City of St. Augustine

Historic Architectural Review Board

A G E N D A

Thursday, August 15, 2019 1:00 p.m.

SHEET 3
BAYFRONT - BEST WESTERN - 16 AVENIDA MENENDEZ
HARB RESUBMISSION 8.15.19
SARAH RYAN ARCHITECT, LLC

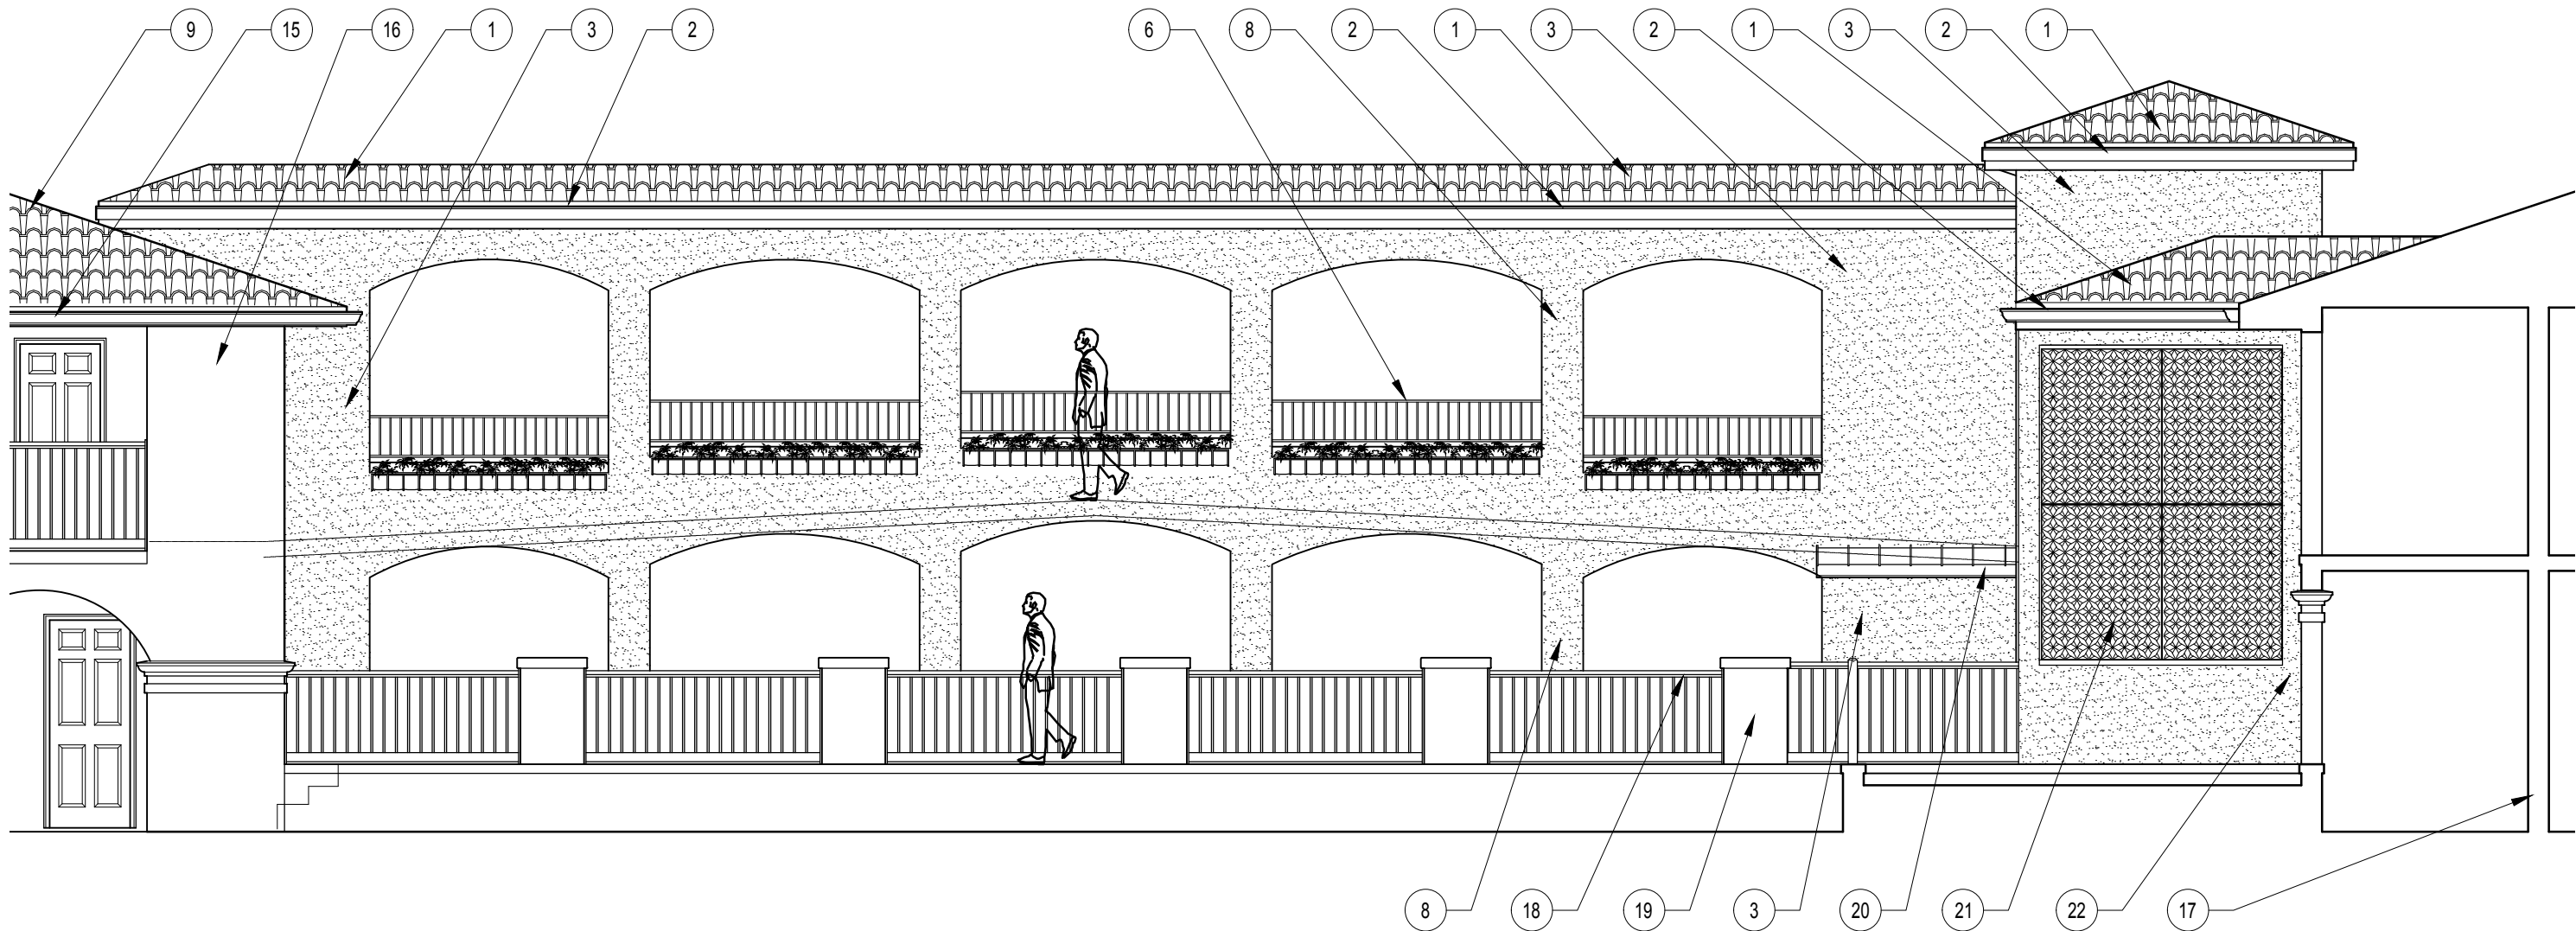
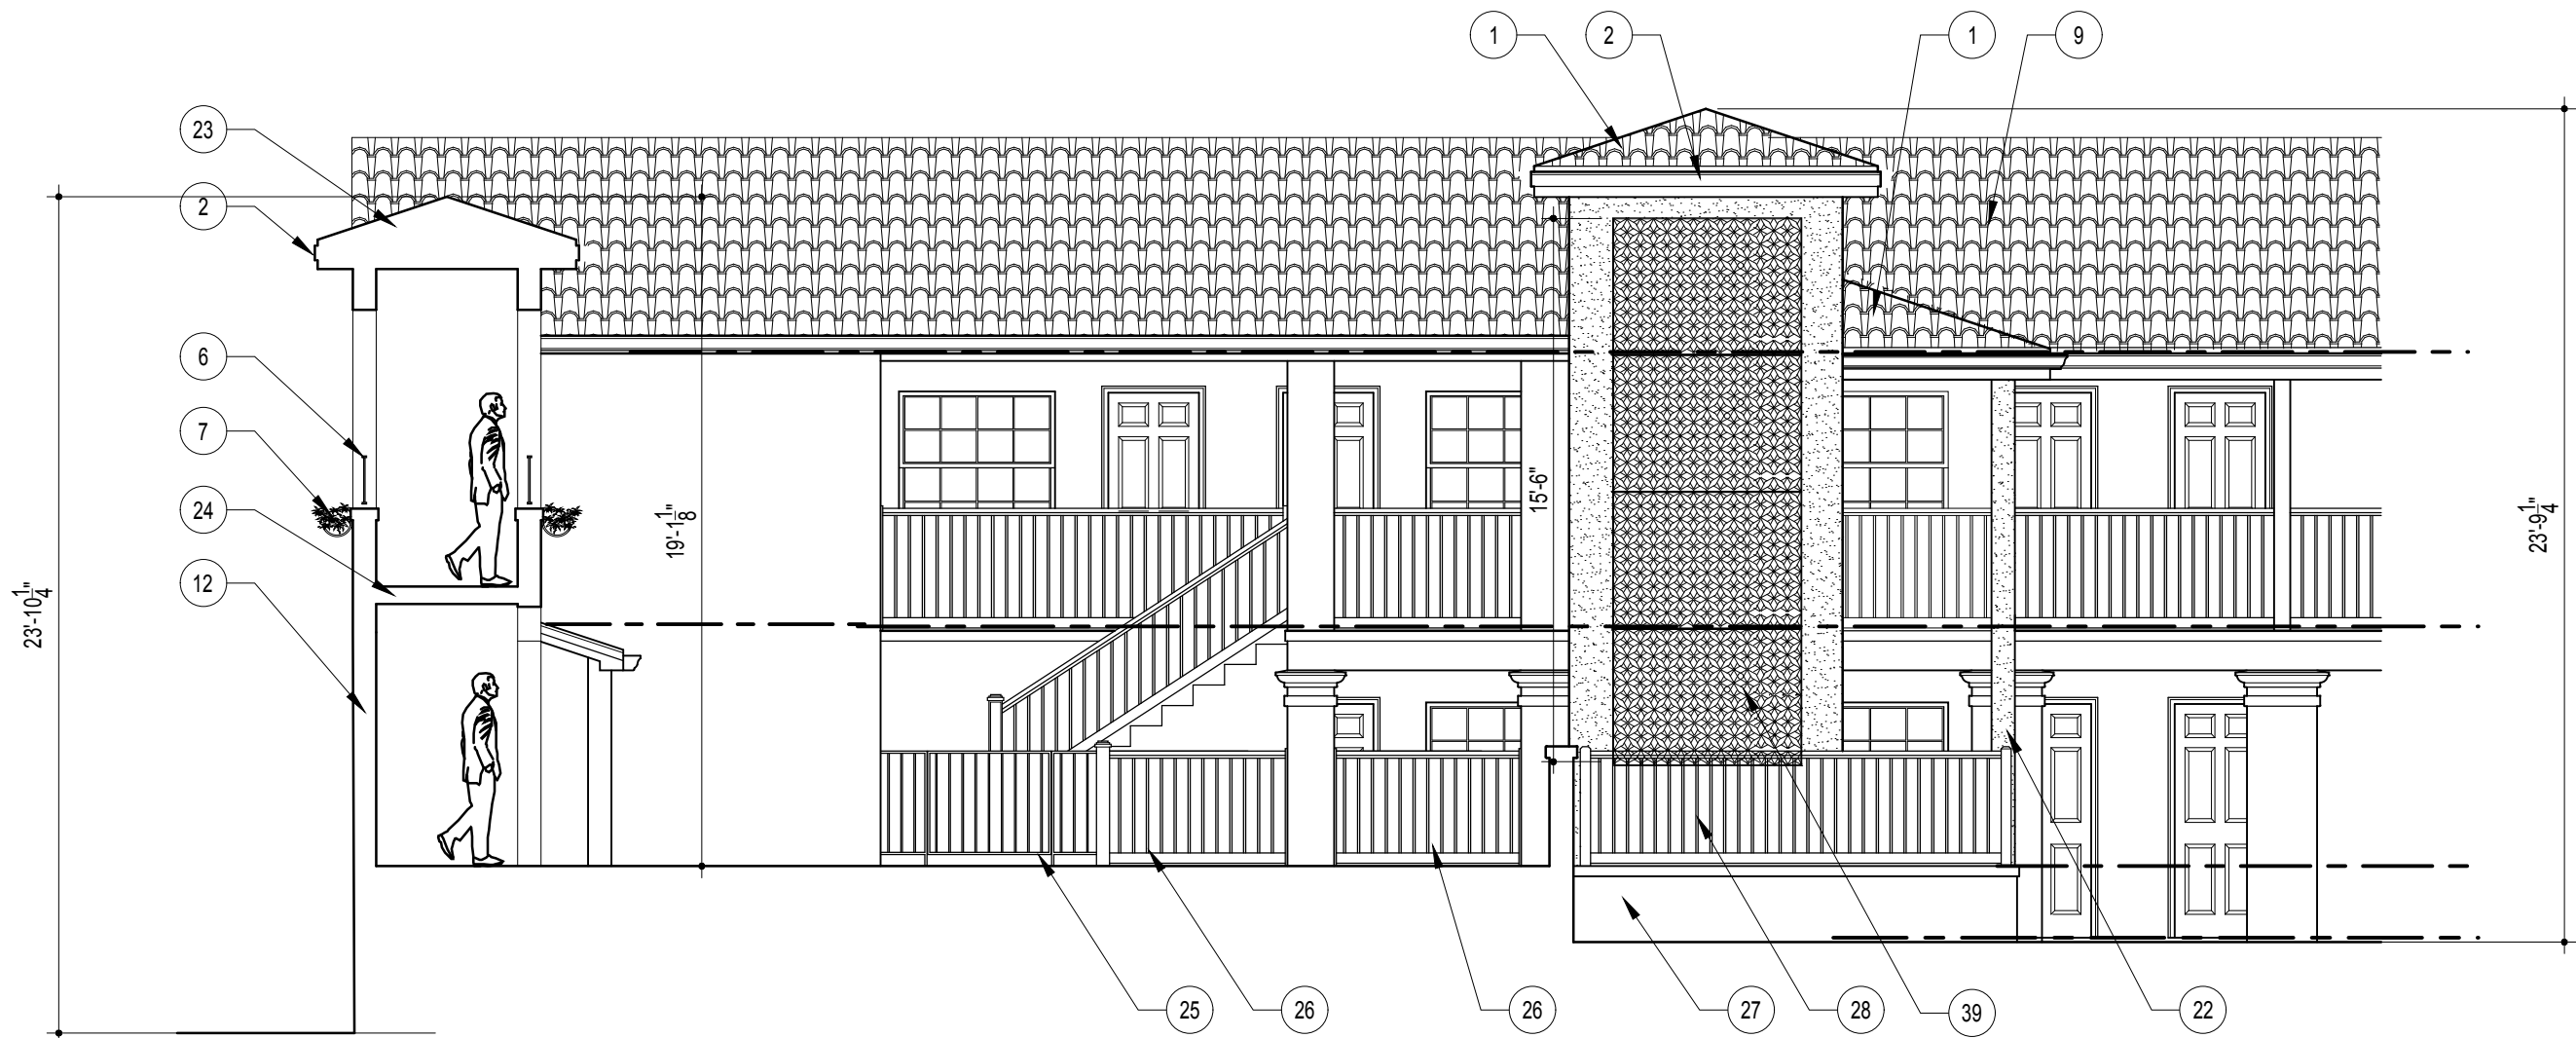
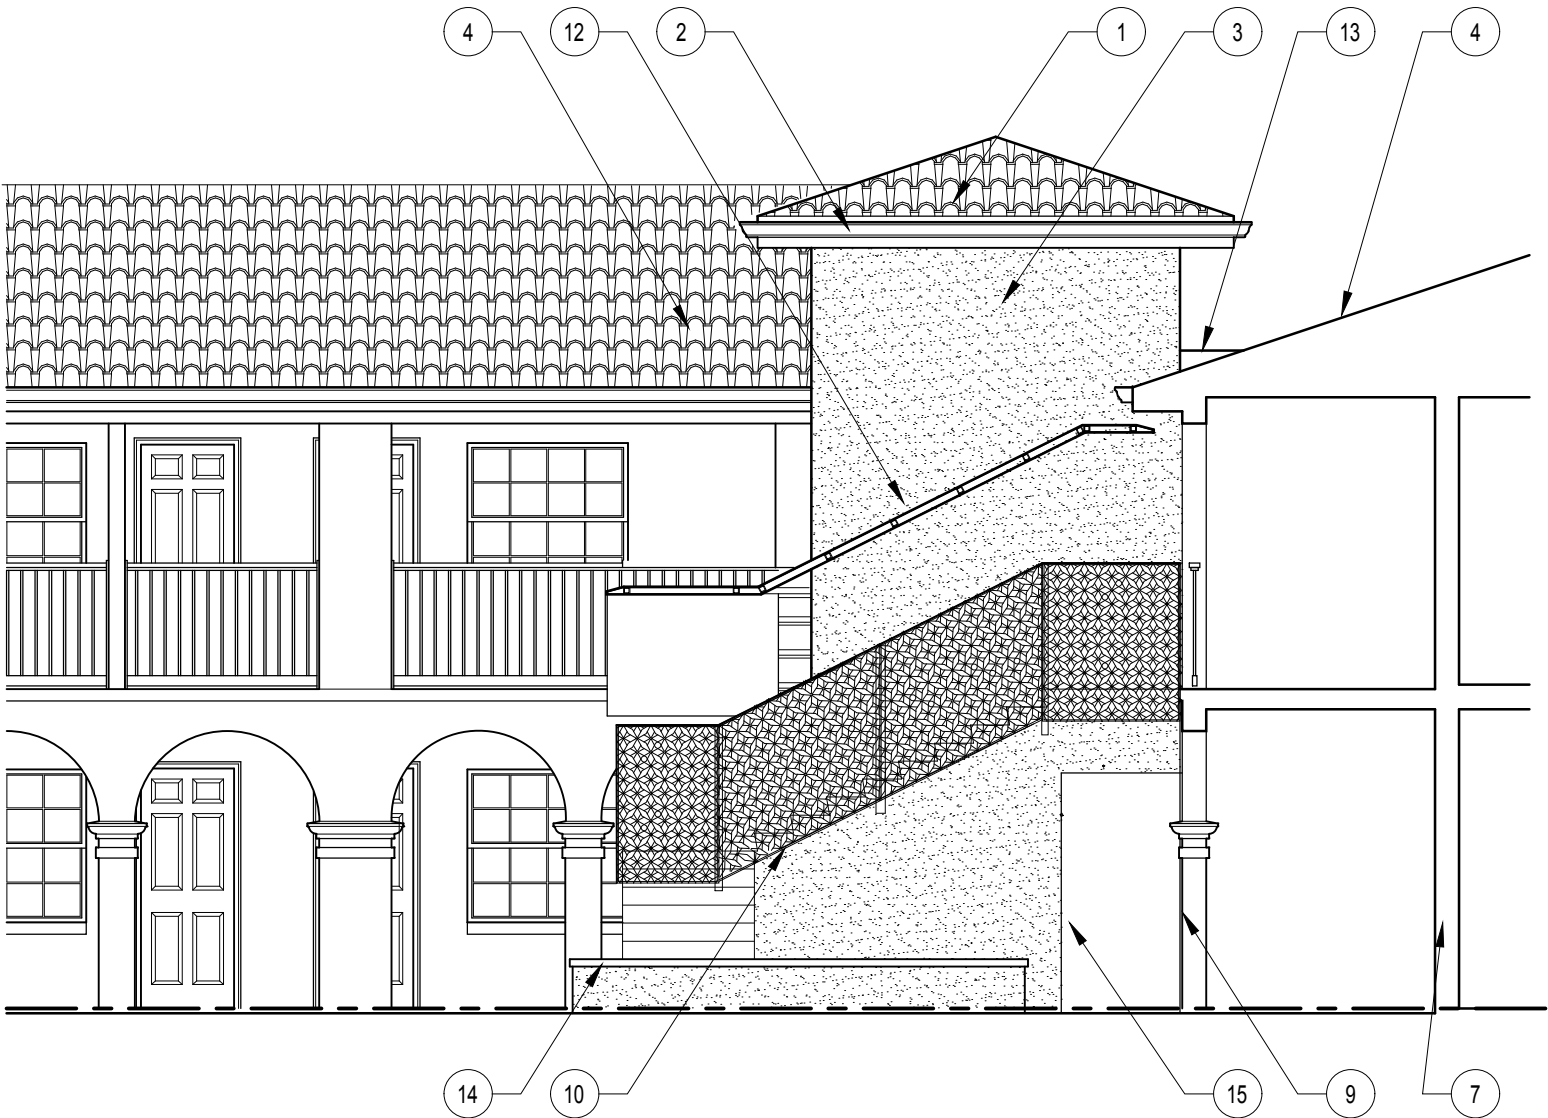
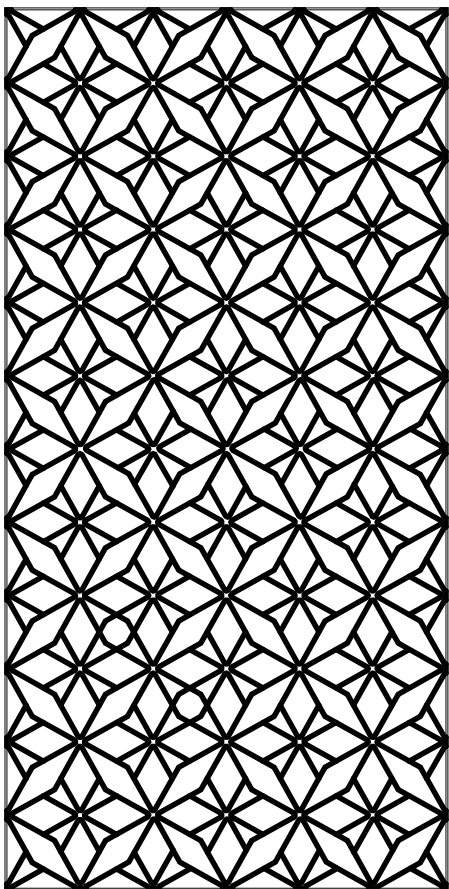
- Is the metal art for the stairs backed with anything? It appears that you can see through it, and I wanted to verify.

- Did you make a change to the canopy?

The shape is the same - we simplified it by removing the rubber type roof. It is all metal now - in keeping with the metal handrails. Sorry this was not in the cover letter description - I updated the detail on the section drawing.
